Re: Proposed Milford Township Draft Wellhead Protection Ordinance – Written Comments by the Delaware Riverkeeper Network before the July 7, 2021 Township Meeting

From: Criswell, Alexander B. [criswellab@cdmsmith.com]
Sent: Wednesday, July 07, 2021 3:54 PM
To: Milford Township; wateropr@gmail.com
Cc: King, Abraham J.; Remphrey, Byrne
Subject: RE: CDM Smith Notification Discussion at the Supervisors' Meeting
Attachments: 2021WSIPlans_MilfordTownship.pdf

WATER SYSTEM IMPROVEMENTS

PLAN AND PROFILE
 STA 12+00 TO STA 18+11

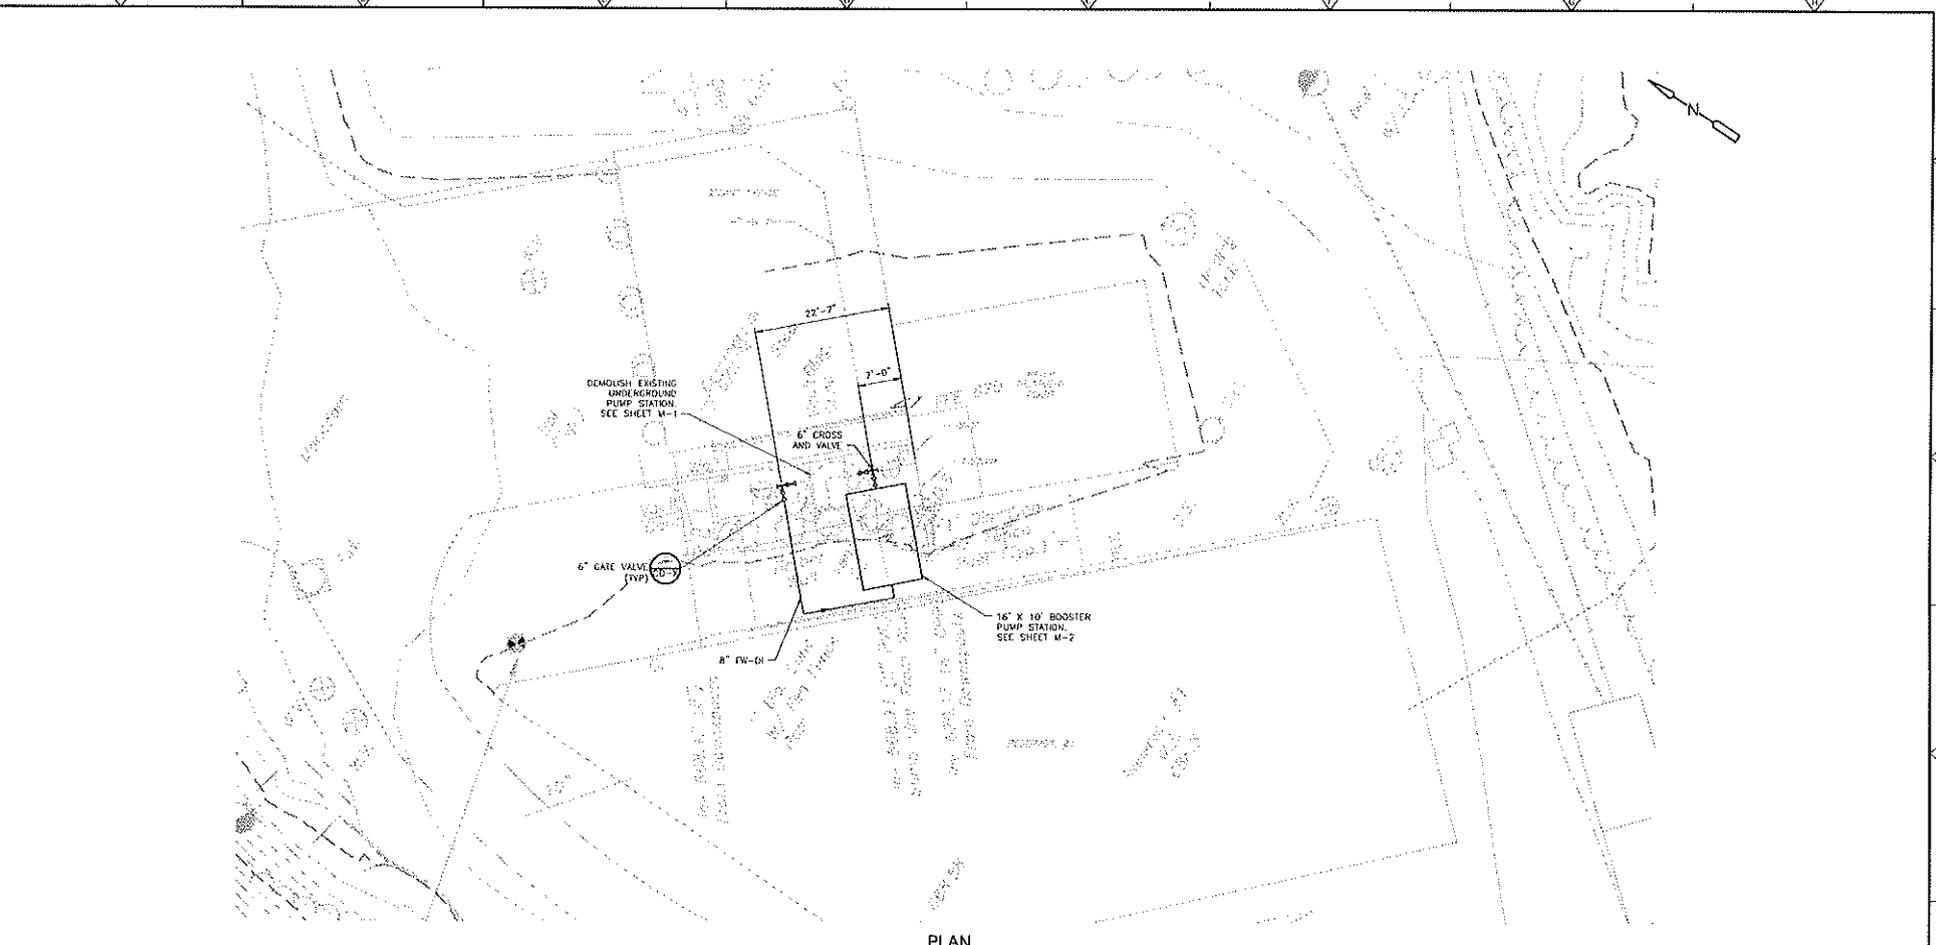
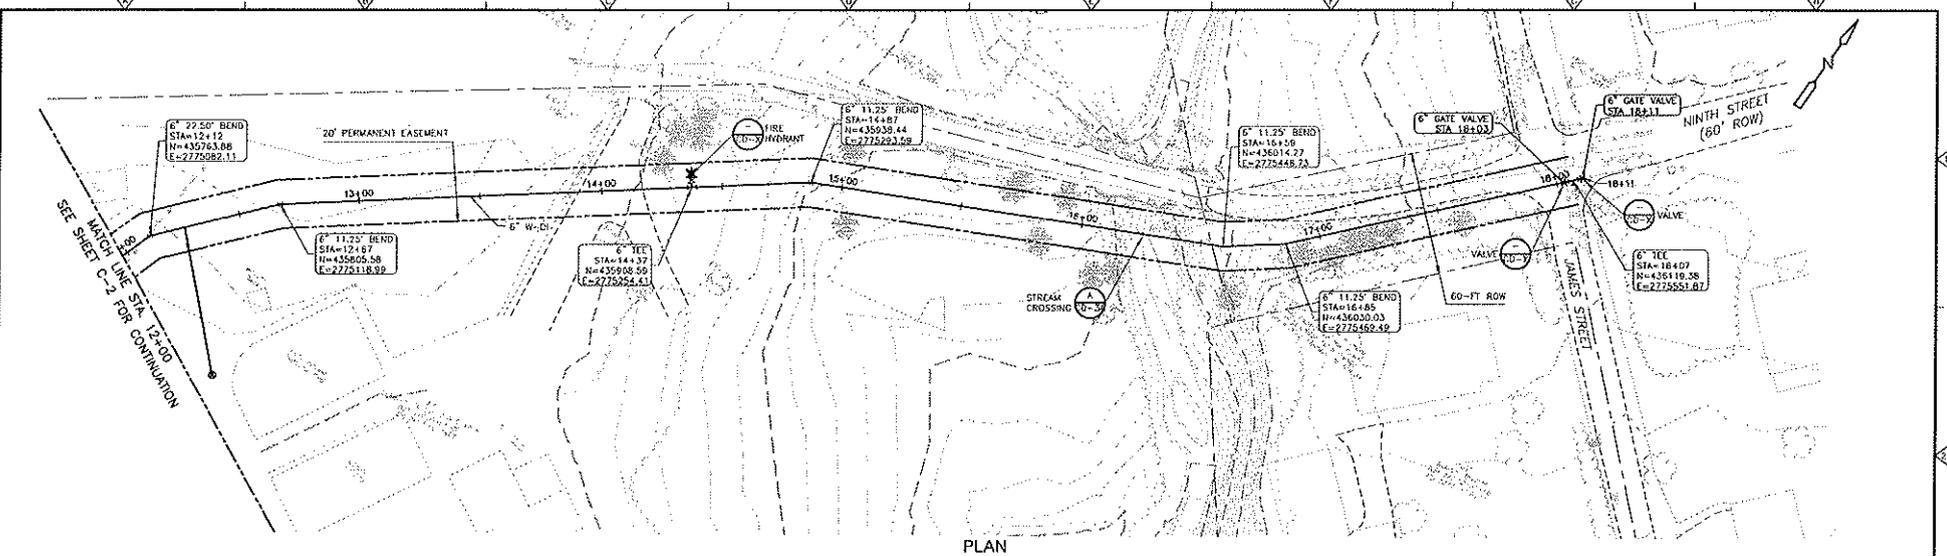
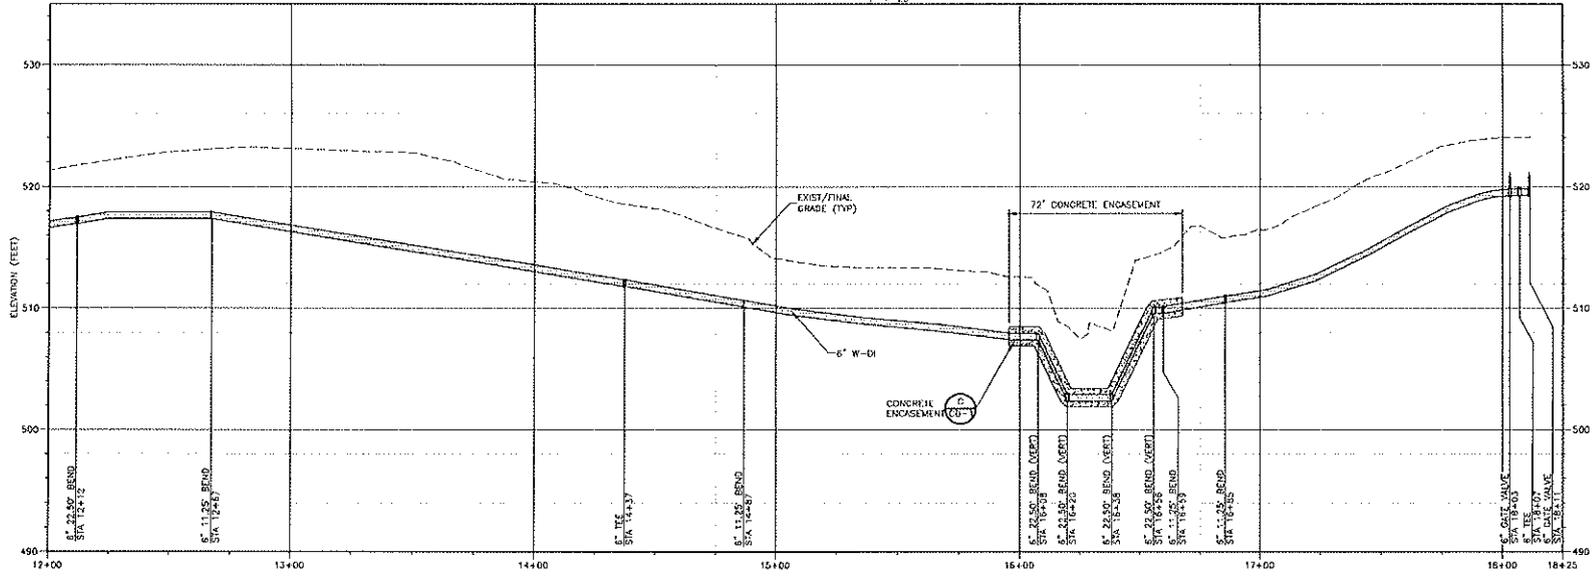
1. What is the exact location of the above ground pump?
2. Is it going to generate any noise or exhaust fumes?
3. What's the distance from the nearest building that is not on sight?
4. In terms of emergency management planning, is there any information about what the potential for flood risk is if one of those towers comes down.
5. Will another stream crossing be added?
6. Check with the Zoning Officer and the Building Officer for what permits would be required.

5. We are planning two stream crossings in our plans, both crossing Vantine creek. Please refer to pages C-3 and C-5 for the location of these crossings. In both cases the pipe will be buried under the stream and encased in concrete. We also plan to install a culvert over the crossing near the treatment plant to facilitate an access driveway for maintenance. In both cases, we show details on sheets CD-3 and CD-3A for how these crossings will be installed. The stream crossing detail on sheet CD-3A also includes erosion and sediment control details specific to these installations as well.
